10/28/20 PCO#2 POLE RELOCATION

19TH AVENUE (STATE ROUTE 1)  
COMBINED CITY PROJECT

19TH AVENUE AND QUINTARA STREET

DRAWING NO. E-12.0

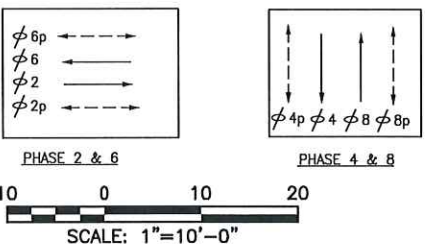
- REUSE AND [RL] EXISTING MAST ARM POLE AS INDICATED BY POLE G ON NEW FOUNDATION. [RL] EXISTING STREET LIGHT FIXTURE. [RC] EXISTING TRAFFIC SIGNAL EQUIPMENT, MOUNTINGS, ASSOCIATED CONDUIT, AND FOUNDATION. PROVIDE NEW TRAFFIC SIGNALS AND MOUNTINGS PER POLE AND EQUIPMENT SCHEDULE. PROVIDE TEMPORARY SIGNAL AND LIGHTING AS REQUIRED.

- REUSE AND [RL] EXISTING MAST ARM POLE AS INDICATED BY POLE C ON NEW FOUNDATION. [RL] EXISTING STREET LIGHT FIXTURE. [RC] EXISTING TRAFFIC SIGNAL EQUIPMENT, MOUNTINGS, ASSOCIATED CONDUIT, AND FOUNDATION. PROVIDE NEW TRAFFIC SIGNALS AND MOUNTINGS PER POLE AND EQUIPMENT SCHEDULE. PROVIDE TEMPORARY SIGNAL AND LIGHTING AS REQUIRED.

- ADJUST POLE TO FINISHED GRADE. COUPLE AND EXTEND ANCHOR BOLTS PER REVISED CALTRANS STANDARD PLANS RSP ES-7B DETAIL C.
- CONTRACTOR TO ADJUST POLE ELEVATION SUCH THAT 1.5" TO 4" IS PROVIDED BETWEEN FINISHED GRADE AND BOTTOM OF BASE PLATE - .25" THREAD TO REMAIN ABOVE THE BOLT.
